Subject: RE: NMED Approval Requested_Well construction for KAFB-106IN1

Conceptual Completion Diagram KAFB-106IN1 Approval Form

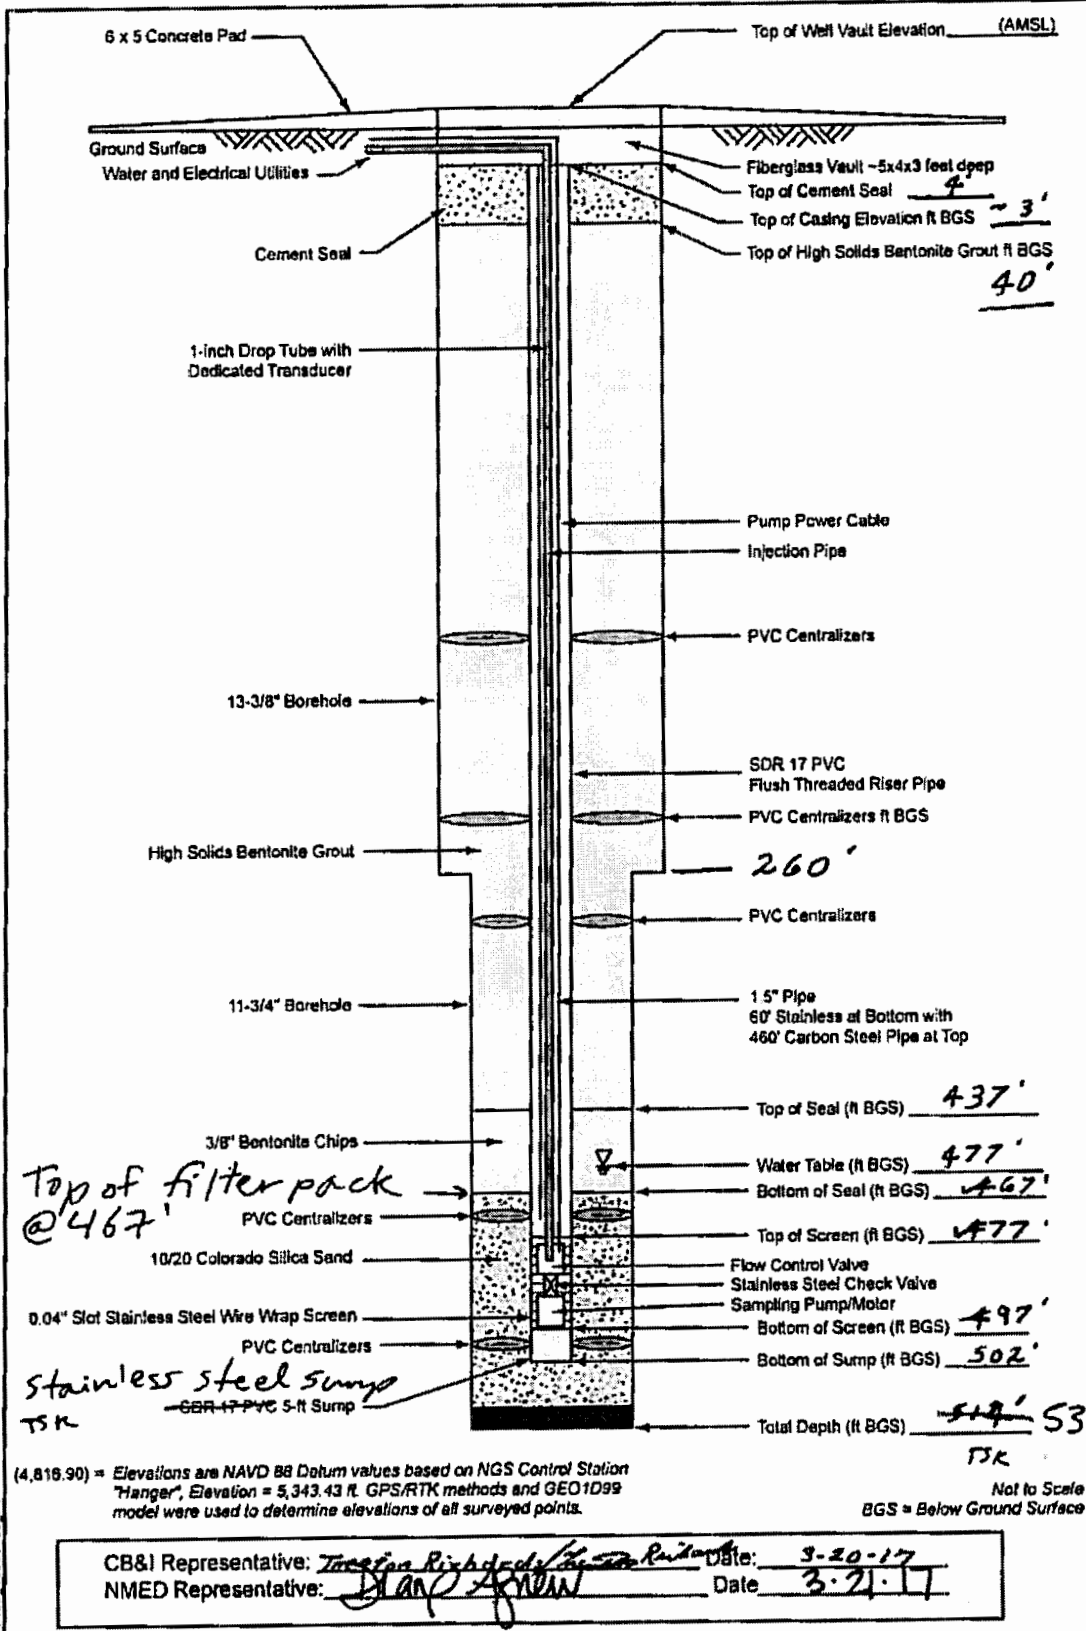
Please find attached the proposed construction diagram for KAFB-106IN1 for NMED approval. Also attached is the compiled borehole log from 0 to total depth of 537 feet bgs. Per the work plan, the injection well has a 20-foot screen with the top set at the static water table with 10 feet of filter pack set above the screen up to the bottom of the bentonite chip seal.

You will see on the construction diagram we are proposing a 30 foot seal of bentonite chips above the filter pack, like we did on the extraction wells. Additionally, we are proposing the same stainless steel sump as was requested at the extraction wells, also reflected on the construction diagram.

The depth to water of 477 feet bgs is the static level being proposed to set KAFB-106IN1.

Attached is the approved well construction diagram.
